Re: Request for Supplemental Information  
Landfill Closure Plan  
Laurens Ceramics Site  
Laurens, South Carolina

On behalf of the Minnesota Mining and Manufacturing Company (3M) and General Electric Company (GE), Roy F. Weston, Inc. (WESTON®) is pleased to submit the supplemental information requested for the closure of the landfill at the Laurens Ceramics site. As you recall in August 1997, the Landfill Closure Plan was submitted to DHEC as required under the Consent Agreement between 3M/GE and DHEC. In your November 1997 telephone conversation with Ms. Sheryl Corrigan (3M), the following supplemental information was requested:

LAURENS CERAMIC SITE  
LANDFILL CLOSURE  
FINAL GRADING PLAN  
LAURENS, SOUTH CAROLINA

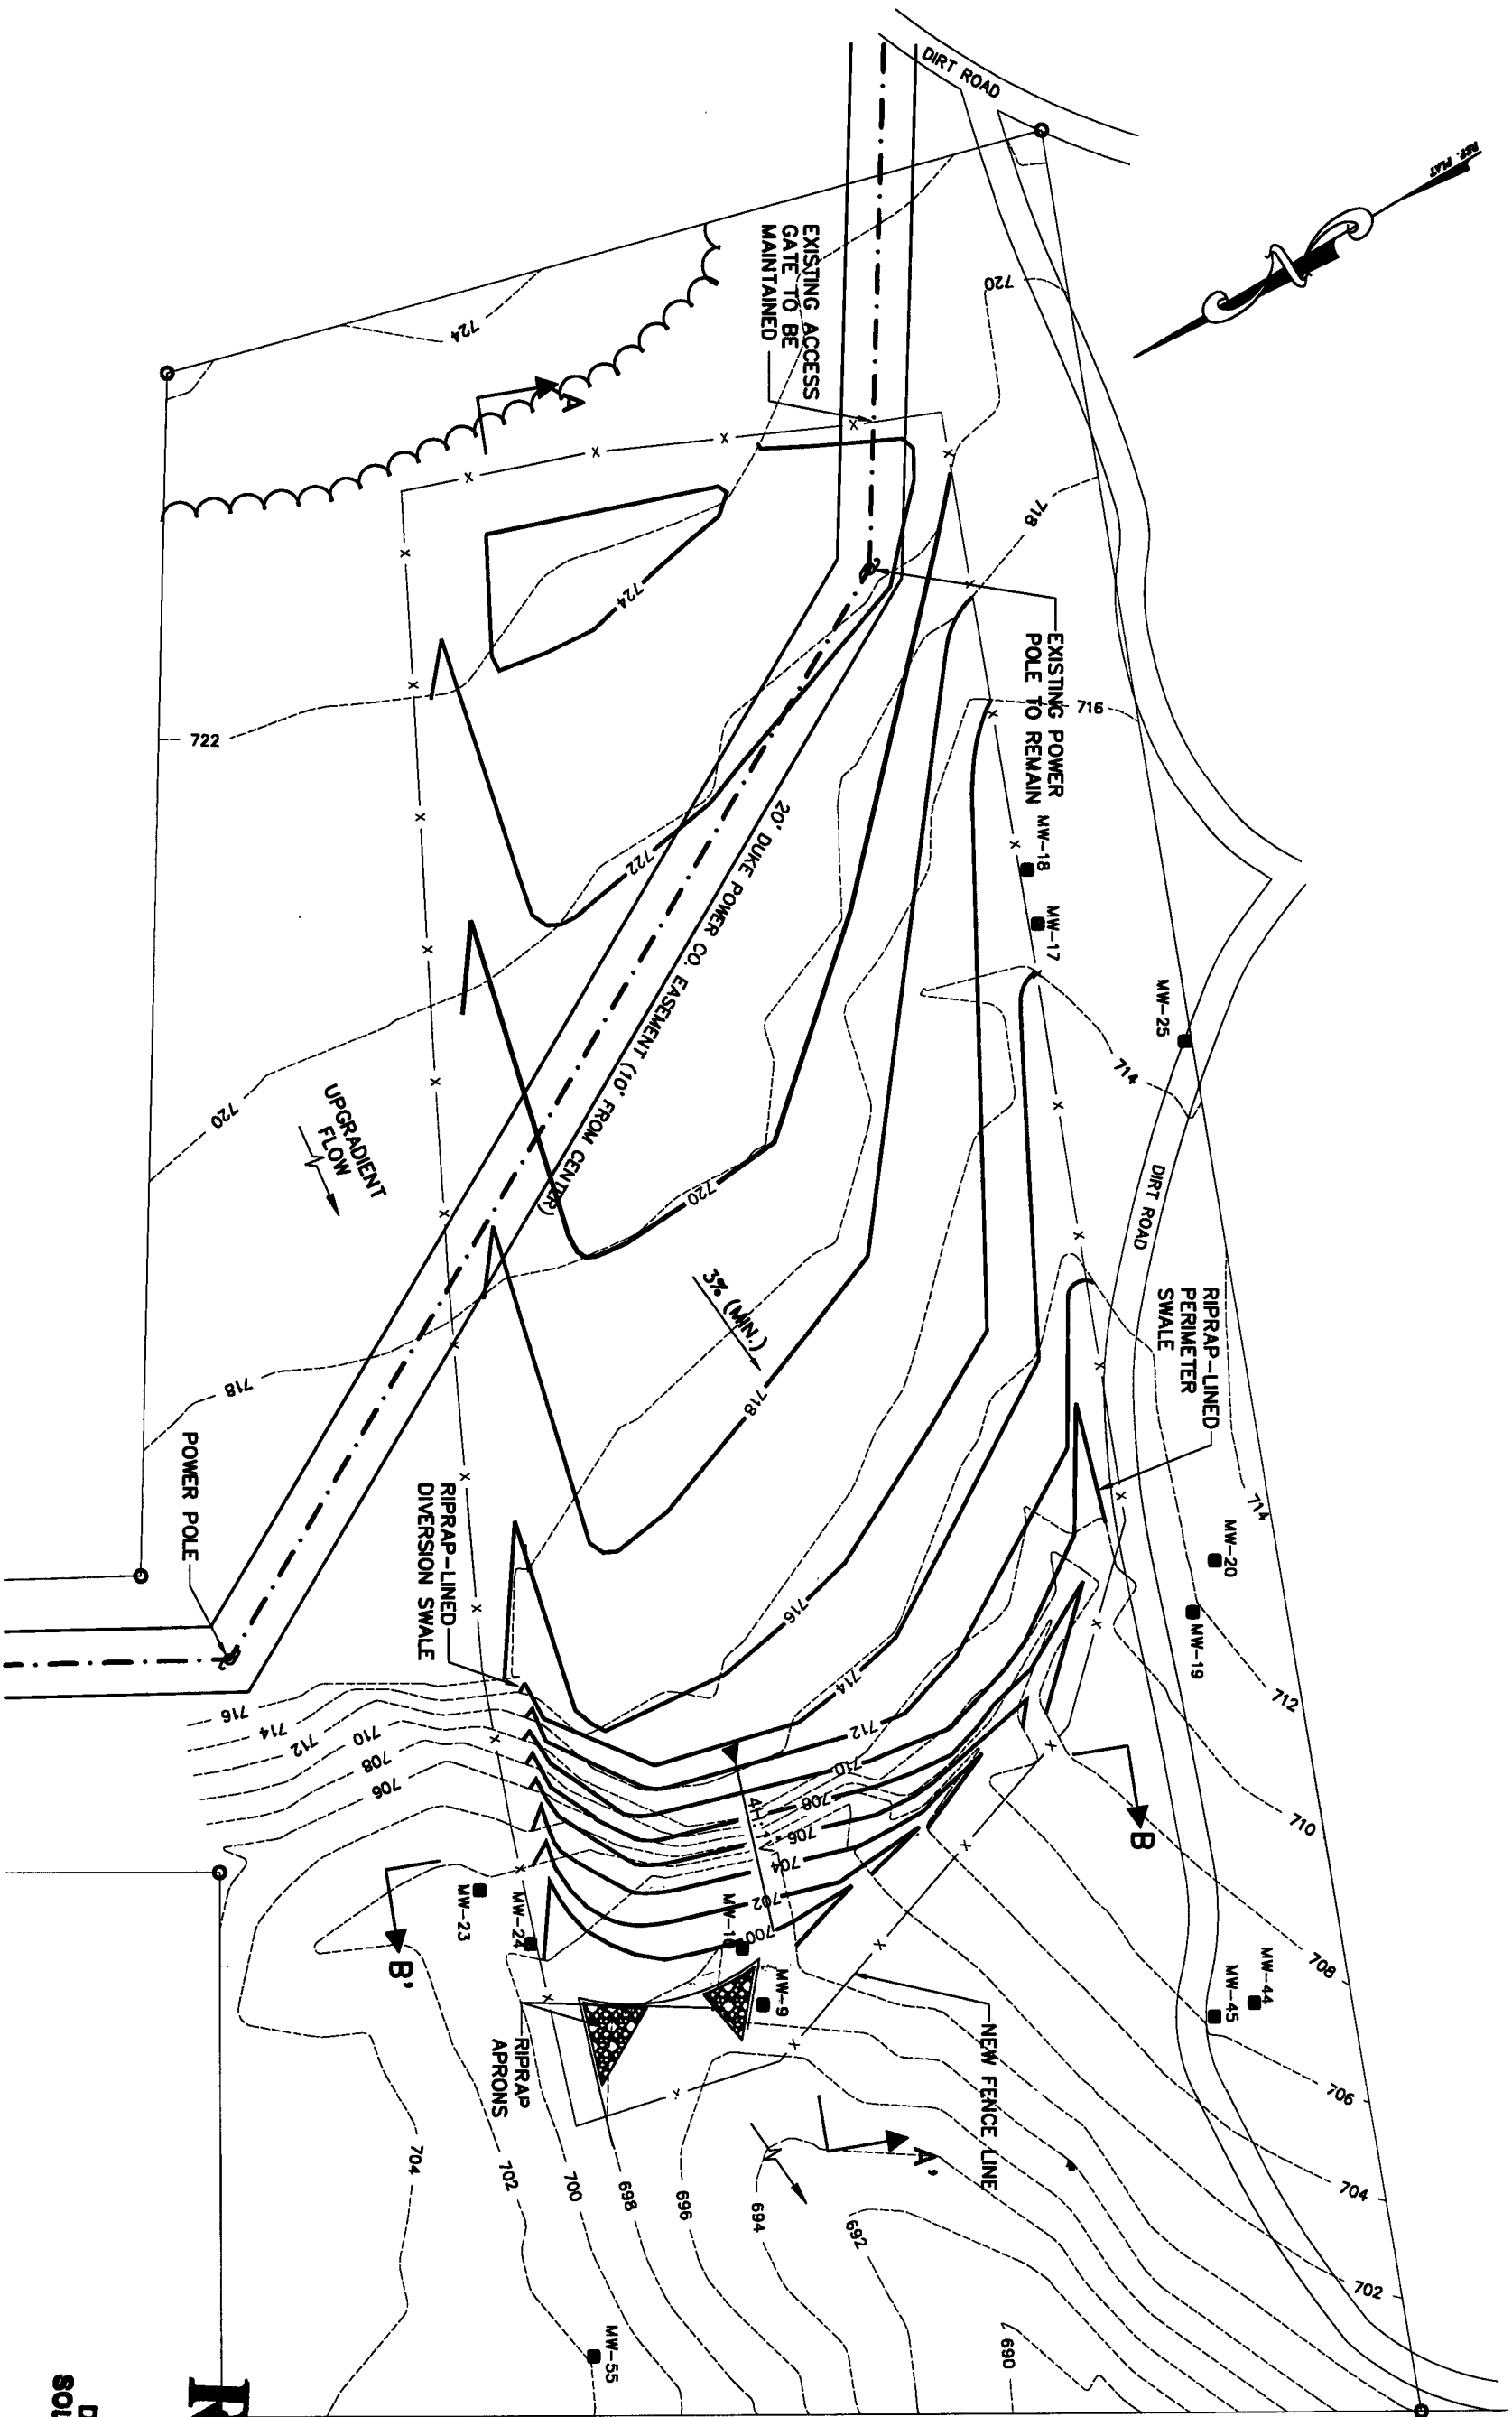
- A final grading plan for the landfill,
- Specified maximum slope,
- Two cross section details,
- Landfill final cover cross section detail,
- Specifications for the GCL (including maximum permeability), and
- Provisions for stormwater management.

The Final Grading Plan for the Landfill is shown in Drawing No. 1 and depicts contours for top of cover. Minor revisions to the final elevations may be made during construction to reflect actual quantities of material being consolidated and imported sub-base material. The final grades specify a maximum average slope of 4H:1V at the "progressive bank" area (at the westernmost portion of the landfill) and a minimum 3% grade on top of the landfill to maintain positive drainage. The 4H:1V slope for the progressive bank area is "flatter" than the present slope which is too steep to provide long term-stability for the final cover. This slope will be regraded via cut of the excess material which will be relocated to the toe of slope. This is shown in the Drawing No. 2 cross-section.

At the western side of the landfill, the swales will discharge onto riprap aprons. The aprons will serve to dissipate the energy of the water and spread the flows evenly across the flat area of the aprons before running off-site via natural drainageways. This stormwater drainage plan is shown in Drawing No. 1.
